**SECTION 00 9111
ADDENDUM NUMBER 02**

DATE: February 10, 2026

PROJECT: Shower House F.W. Kent Park

PROJECT NUMBER: 2250000910

1 SOLAR ROOF PLAN

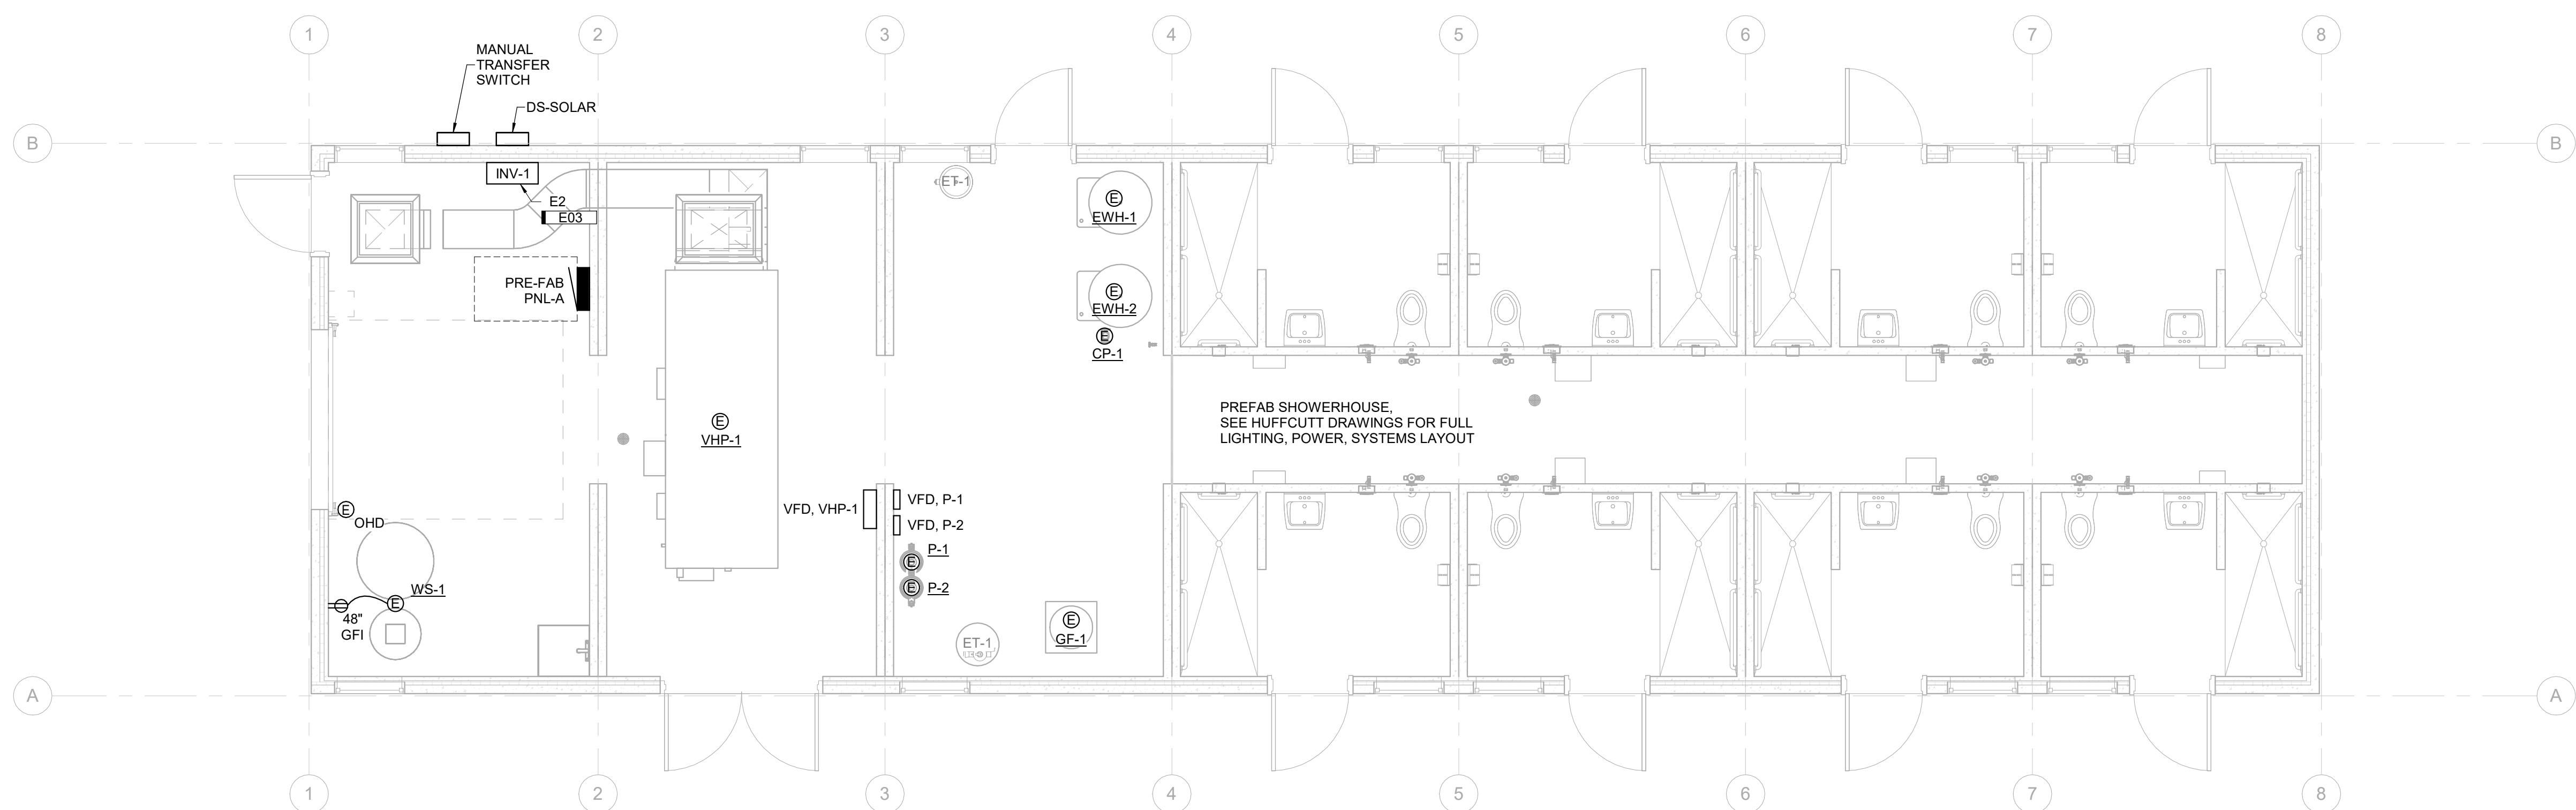
- 8. SHEET E100
 - a. CHANGE solar module to 440W instead of 700W.
- 9. SHEET E500
 - a. CHANGE solar module to 440W instead of 700W.

KEYNOTES	
KEY	NOTE
E02	440 WATT SOLAR MODULE MOUNTED TO PRECAST ROOF. MOUNT PER PRECAST AND MODULE MANUFACTURER RECOMMENDATIONS.
E03	NEW INVERTER TO BE CONNECTED TO EXISTING SOLAR EDGE INVERTERS ON EXISTING GROUND MOUNTED SOLAR INSTALLATION. FURNISH AND INSTALL MEDIA CONVERTERS AND UTILIZE EXISTING FIBER NETWORK TO CONNECT THE INVERTERS.
